CERTIFICATE OF APPROPRIATENESS

ITEM E05
HPO File #: HP2026_0168

7923 Glenalta St.
Glenbrook Valley

Proposal: Alteration – Square footage addition

ELEVATION DRAWINGS CONTINUED

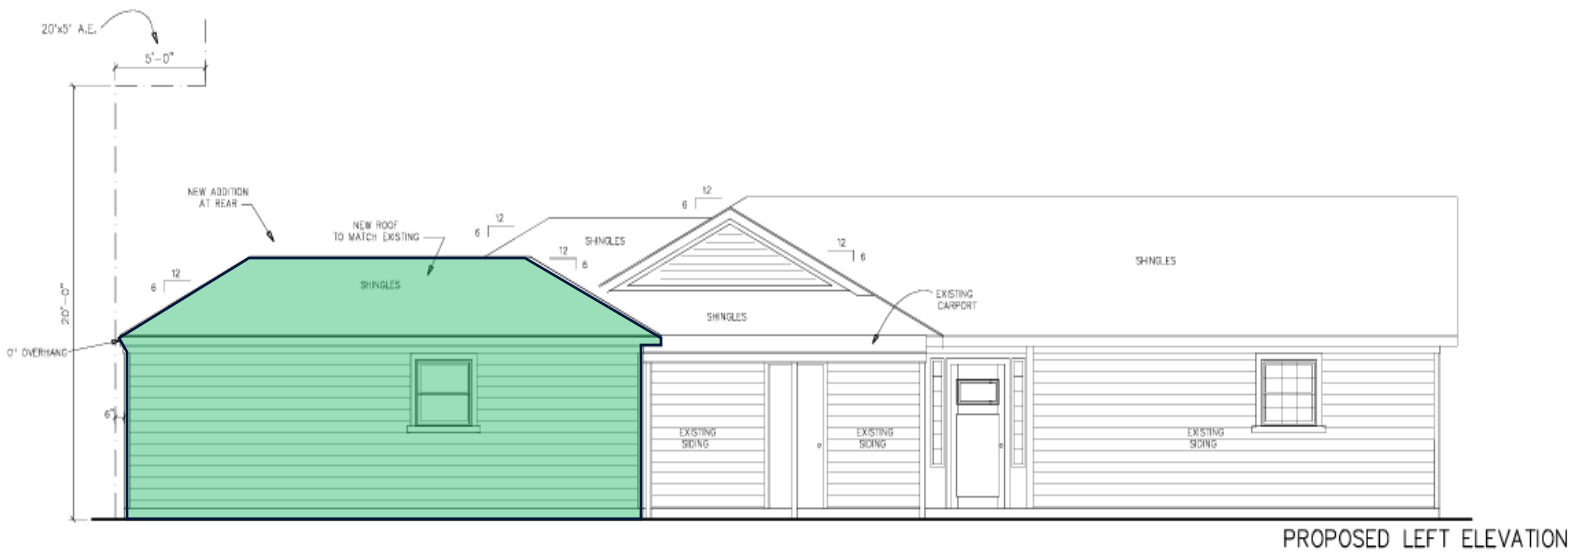
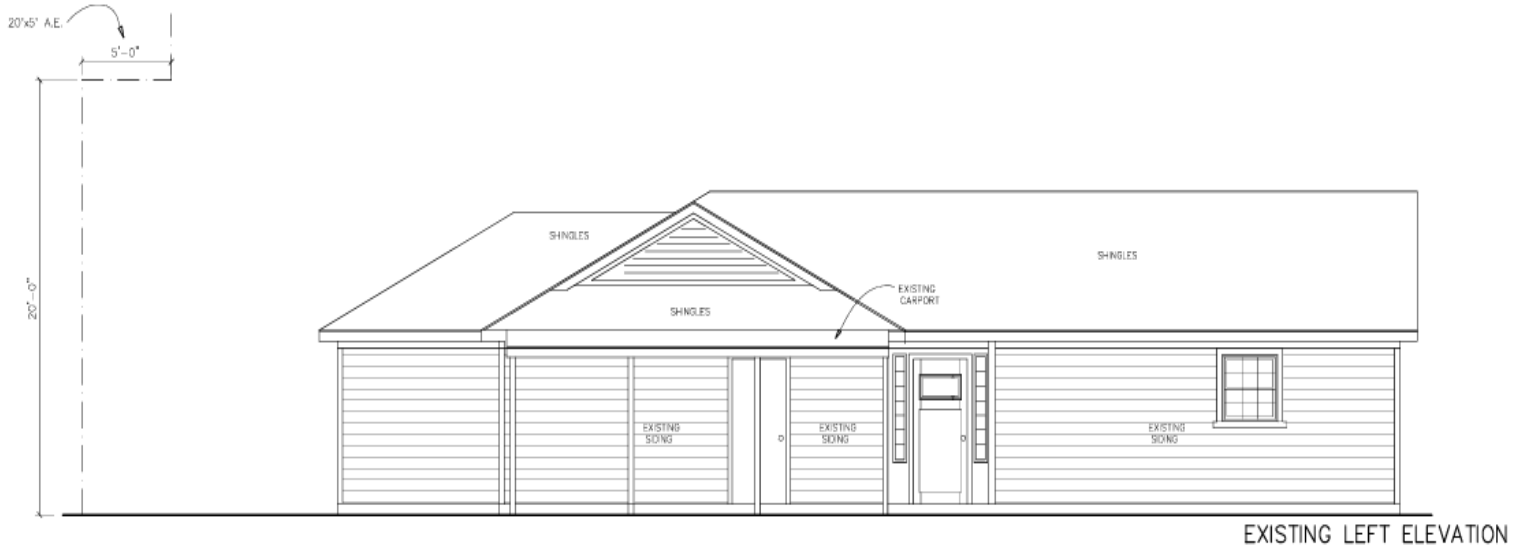
Recommendation: Approval with conditions: that the proposed windows be aluminum

<i>The proposed design includes vinyl windows, which goes against HOP Internal Policy 1-1. With the approval with conditions to change the windows to aluminum, this criteria will be satisfied.</i> |

ATTACHMENT A – WINDOW DIAGRAM

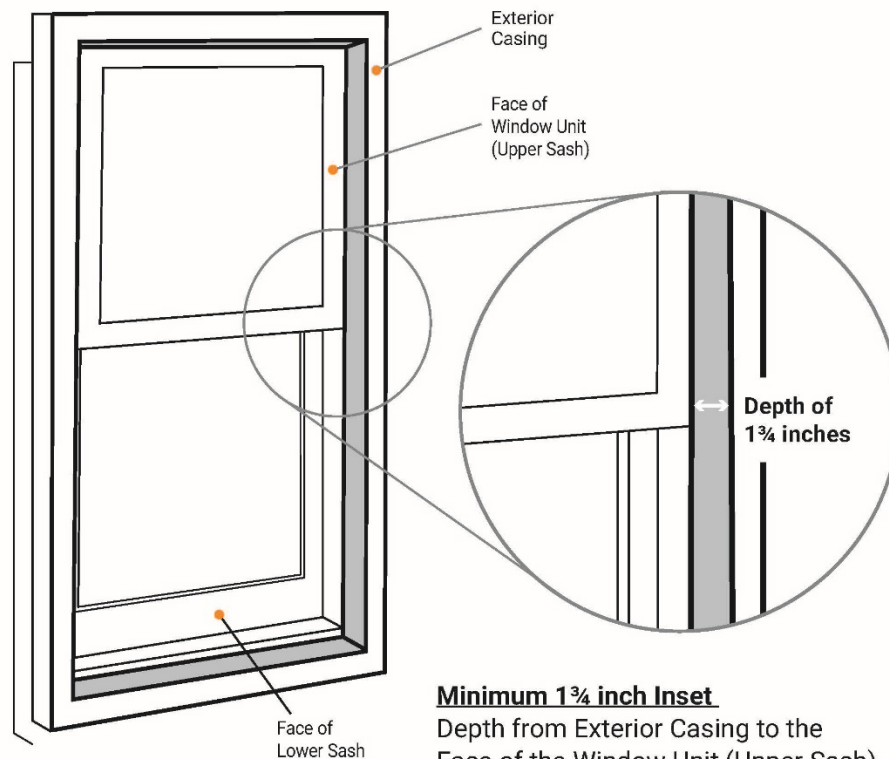
Historic Window Standard: New Construction & Replacement

Windows must be 1-over-1
(equally horizontally divided)

1 3/4 inch minimum inset for Fixed Window
